Staff Report to the Western Weber Planning Commission

Application Request: Consideration and action on a request for preliminary plan approval of Sunset Equestrian Cluster Subdivision.
Type of Decision: Administrative
Agenda Date: Tuesday, September 12, 2017
Owner: Fieldbrook Taylor Partners, LLC
Authorized Representative: Doug Nosler
File Number: LVS080717

SUNSET EQUESTRIAN Cluster Subdivision

MATCH LINE SEE SHEET 3

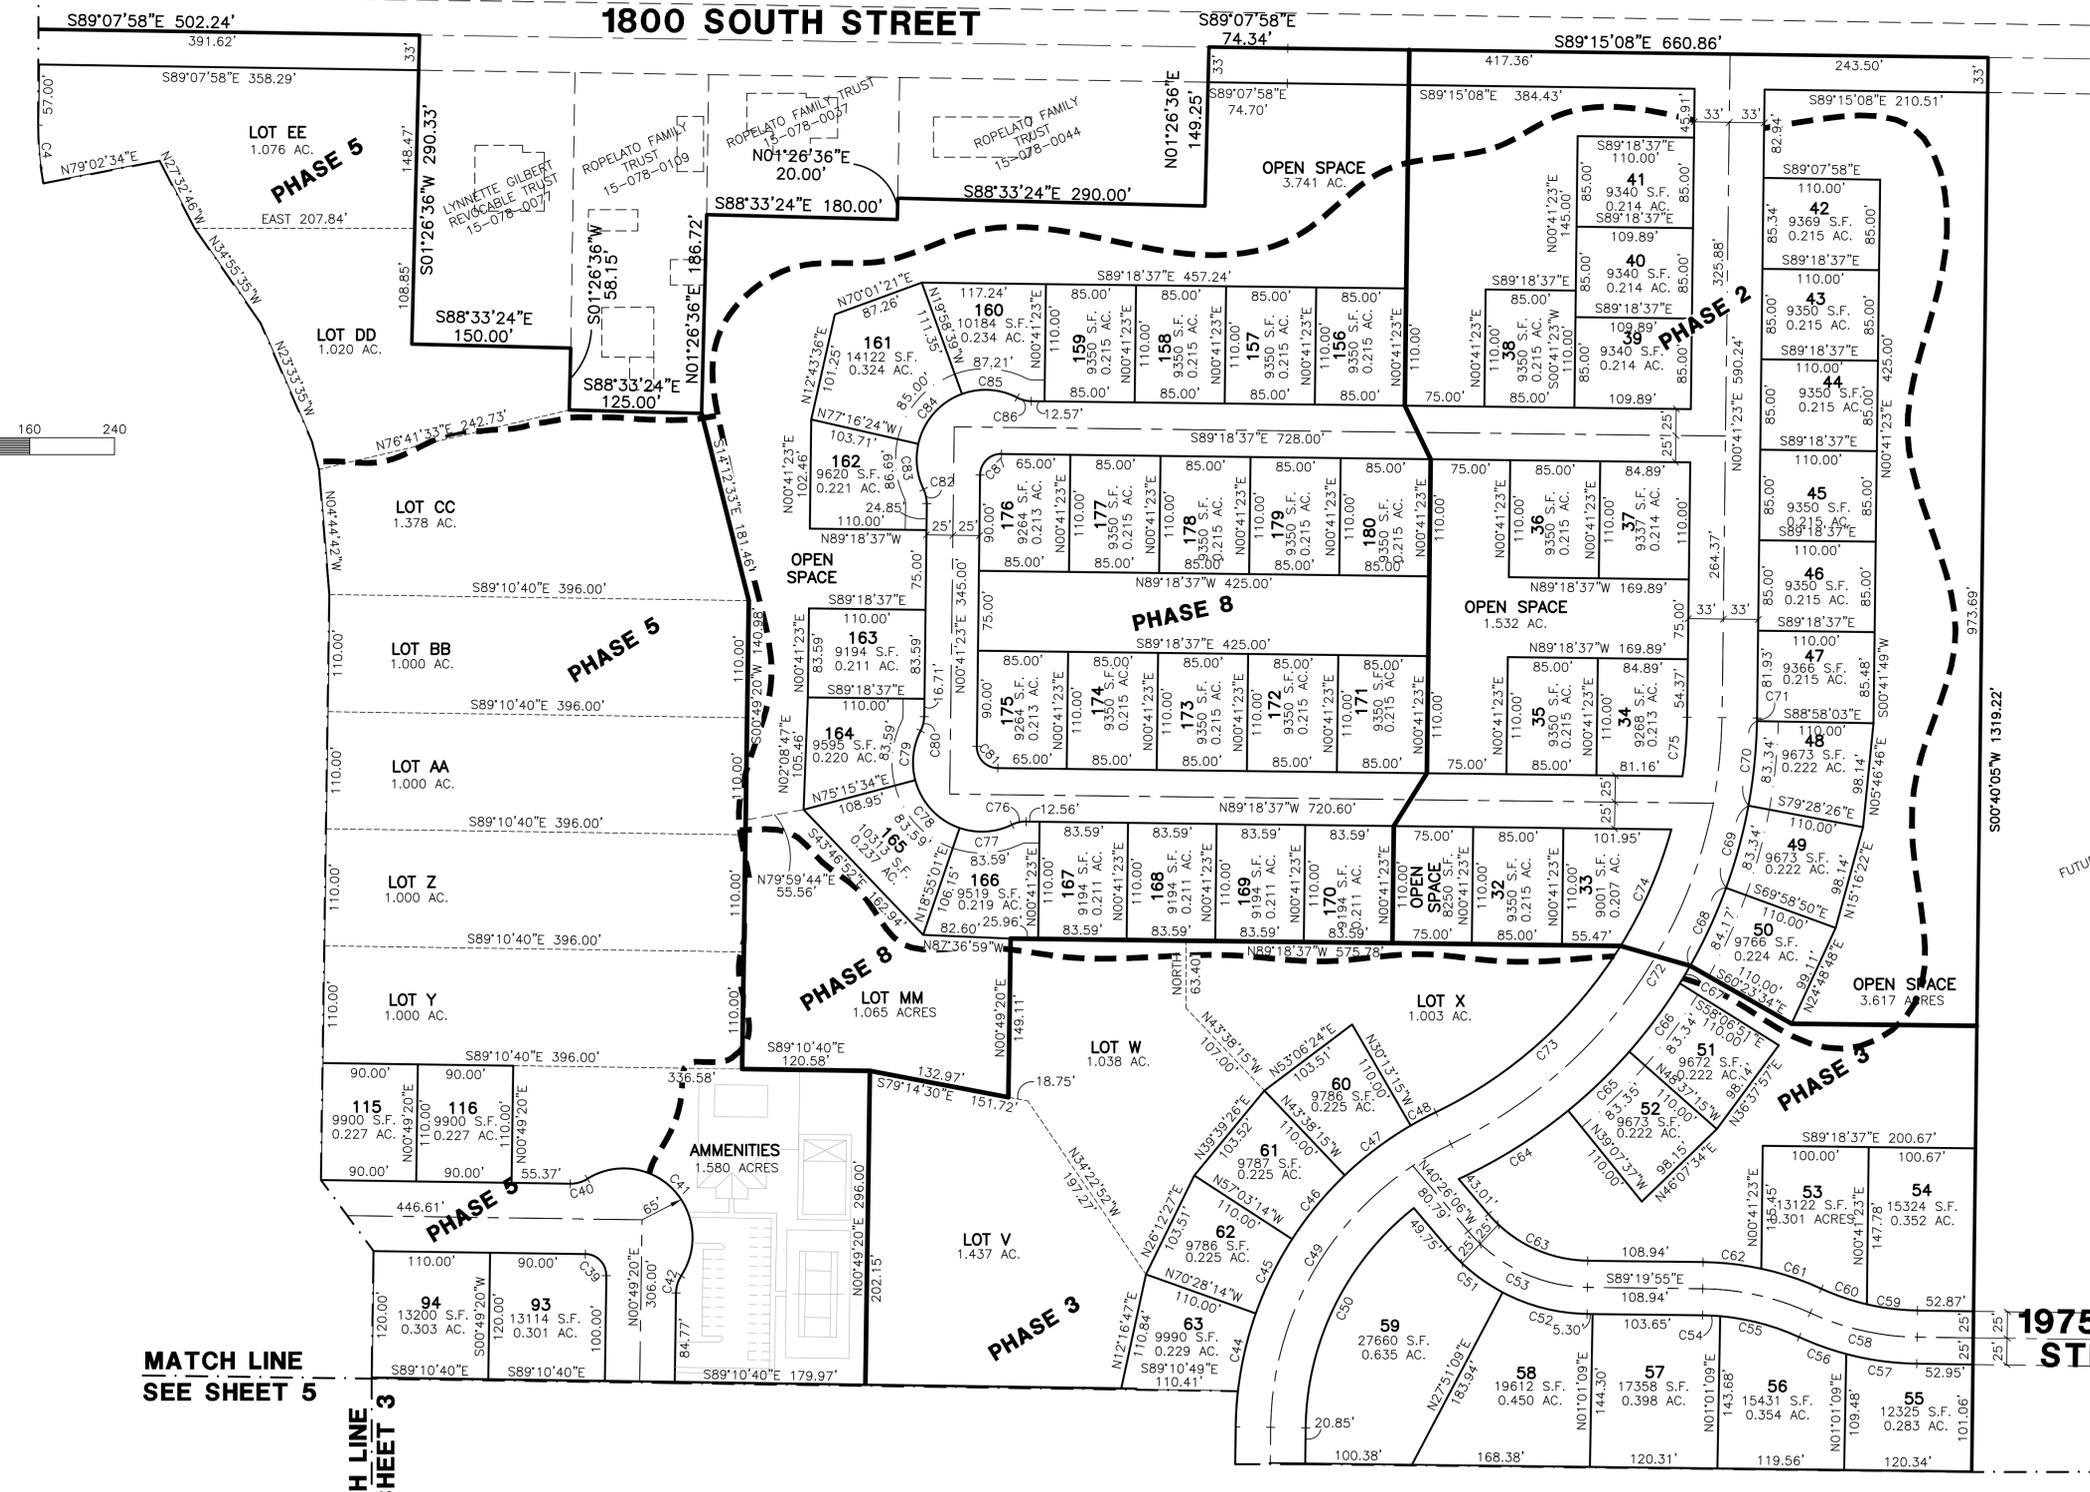
Cluster subdivision design and layout standards: The applicant is proposing curb, gutter, and sidewalk along both sides of all proposed streets, according to the submitted preliminary plan (Exhibit A). All lots within the proposed cluster subdivision meet the minimum lot width requirement of 60' per LUC §108-3-7(2)(c). The proposed cluster subdivision meets the open space width requirements of 75' between clusters of lots per LUC §108-3-4(1). The proposal also consists of several clusters of lots, not exceeding 20 lots per cluster as outlined in LUC §108-3-4-2.

The applicant has proposed to implement walking and equestrian trails within the common area and agricultural open space parcels throughout the subdivision. The location of the proposed trails is on the preliminary subdivision plans (Exhibit A). The West Central Weber County General Plan indicates that equestrian trails are highly desired in the area. The proposed walking and equestrian trails should comply with the multi-purpose trail cross section shown in the West Central Weber County General Plan (2003 *West Central Weber County General Plan: Trails*).

Additional design standards and requirements: The proposed cluster subdivision will have 50', 60', and 66' width dedicated county roads extending through the subdivision to the adjacent property to provide future connectivity to the surrounding area.

Tree & Street Light Plan

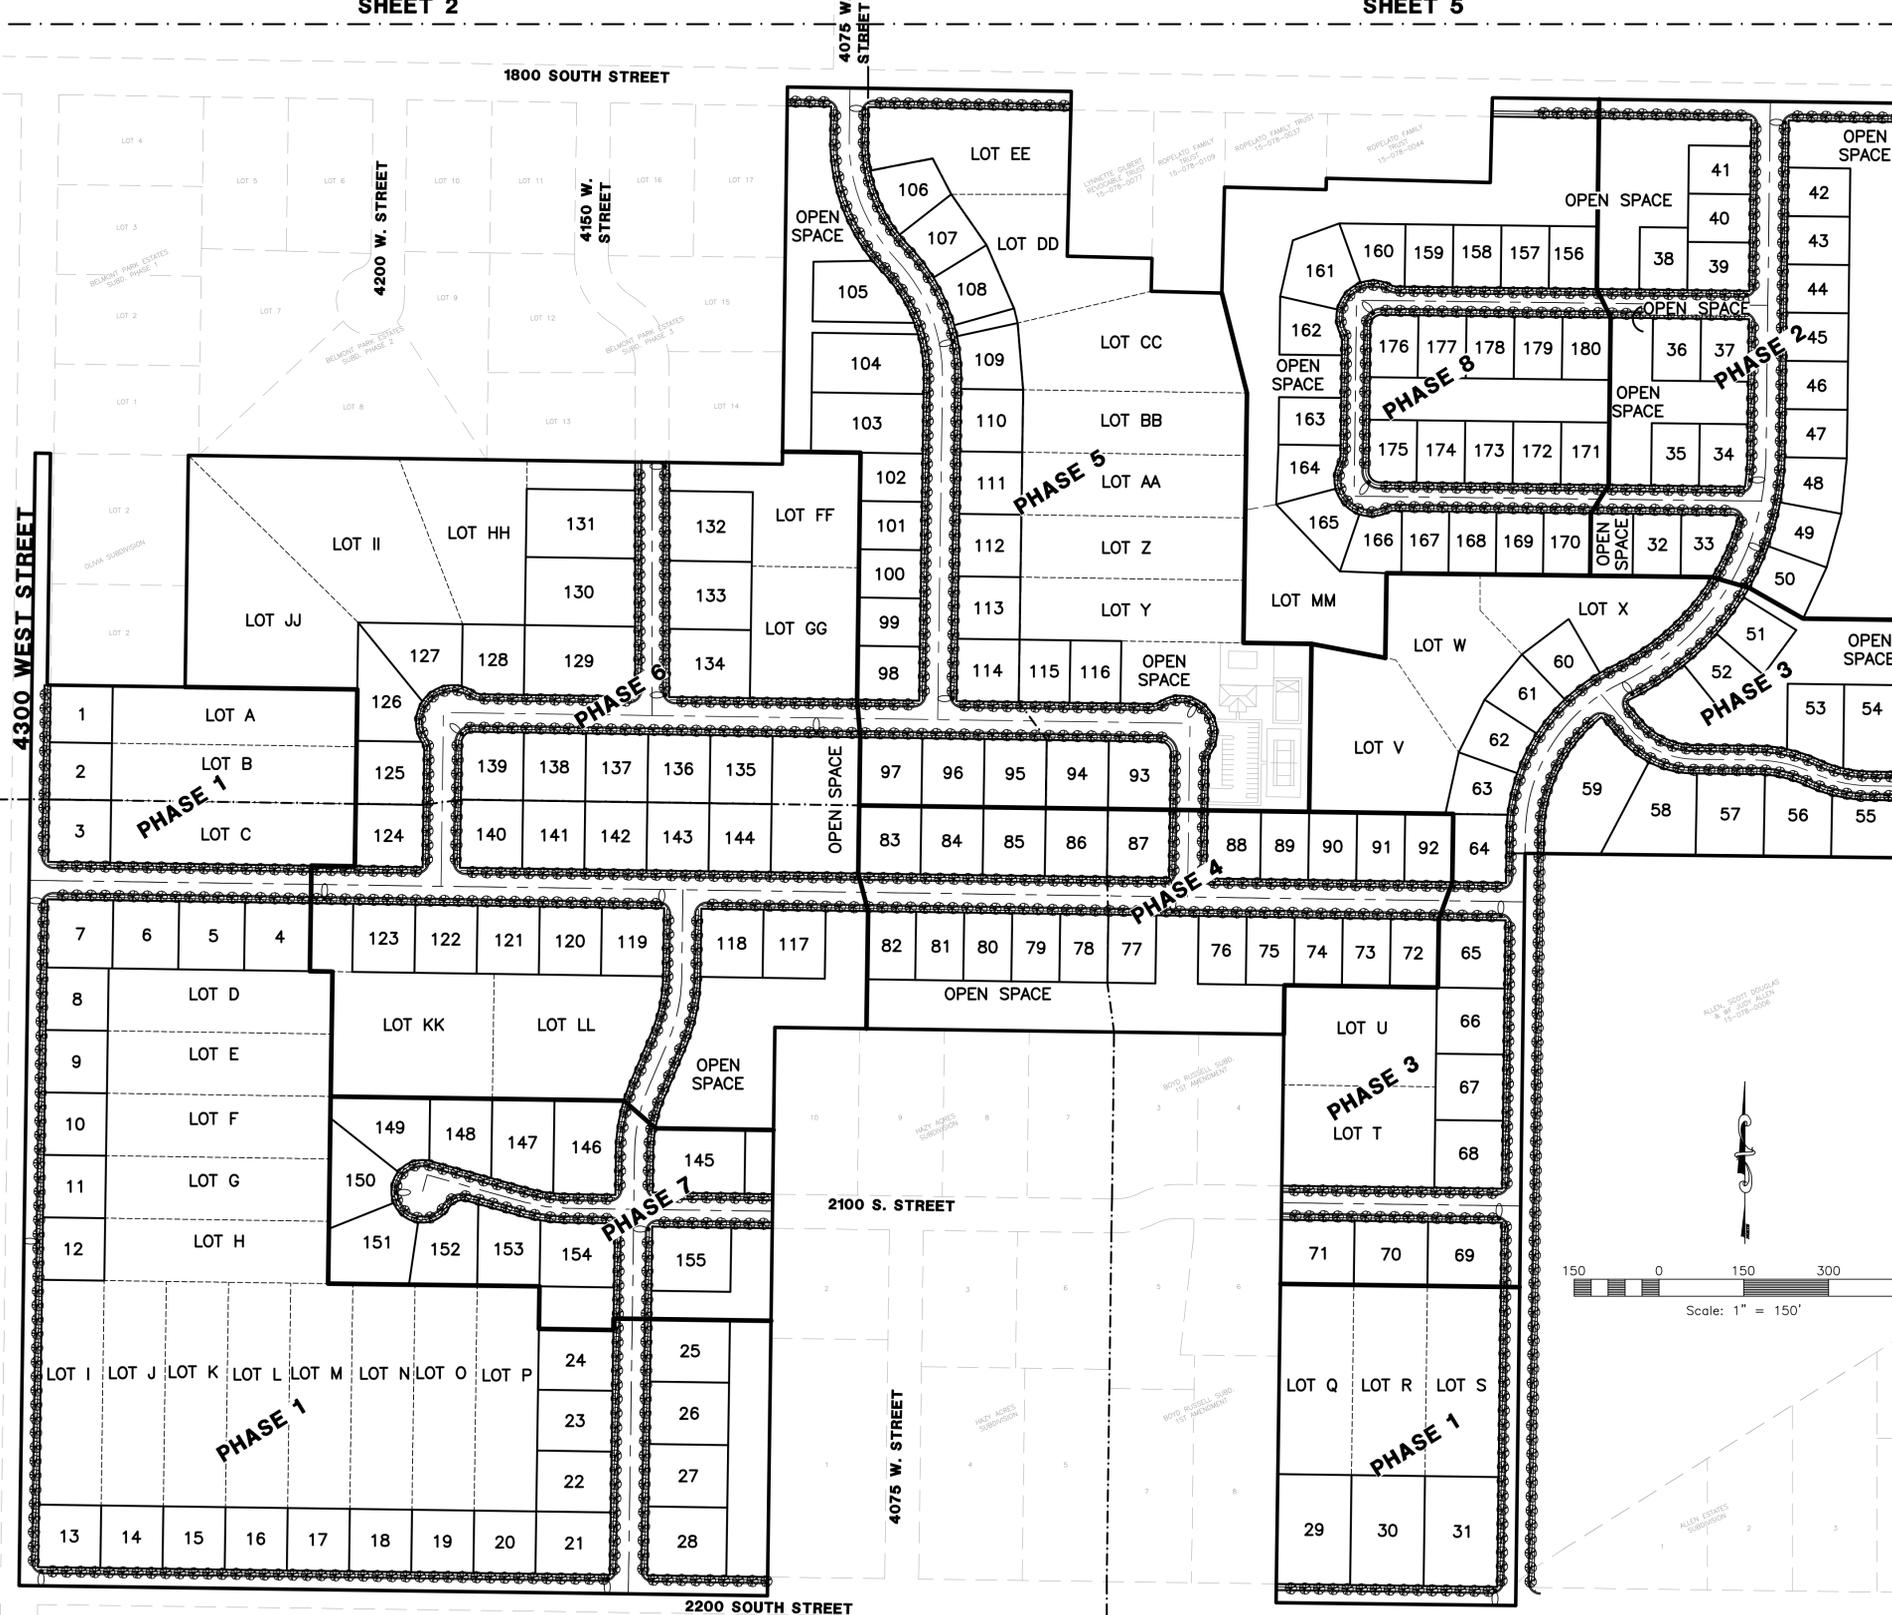
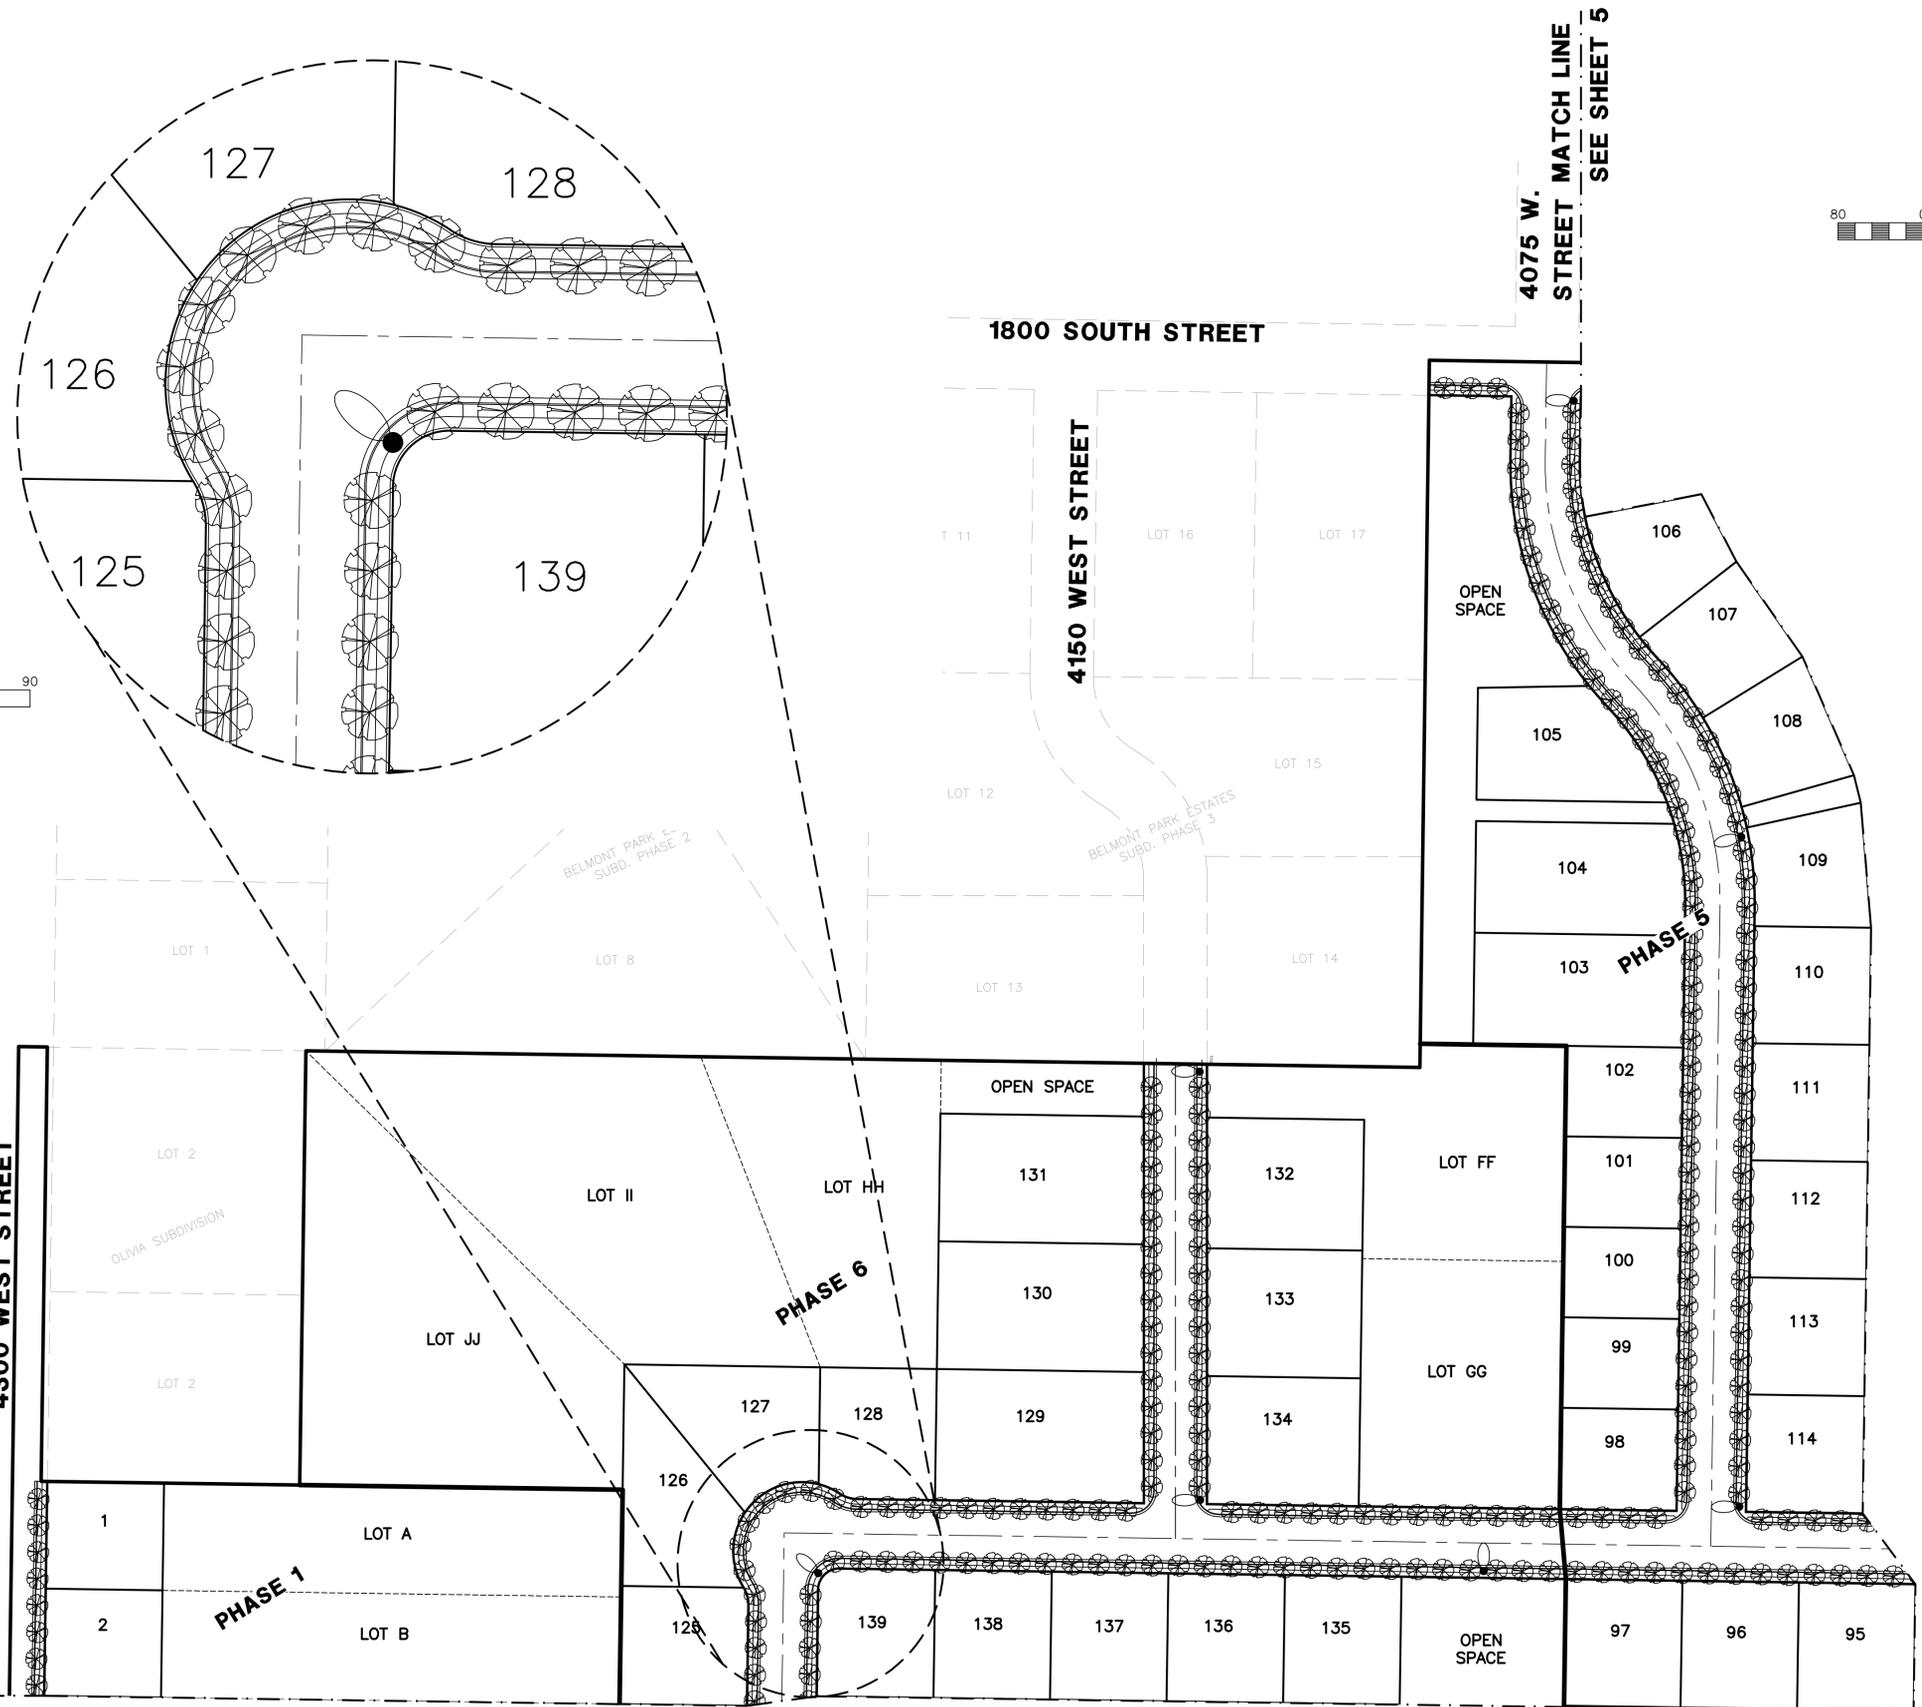
The applicant has provided a roadway landscape and design plan (Exhibit B) including street lights and street trees of the correct caliper, which will be planted according to §108-3-8 (b).
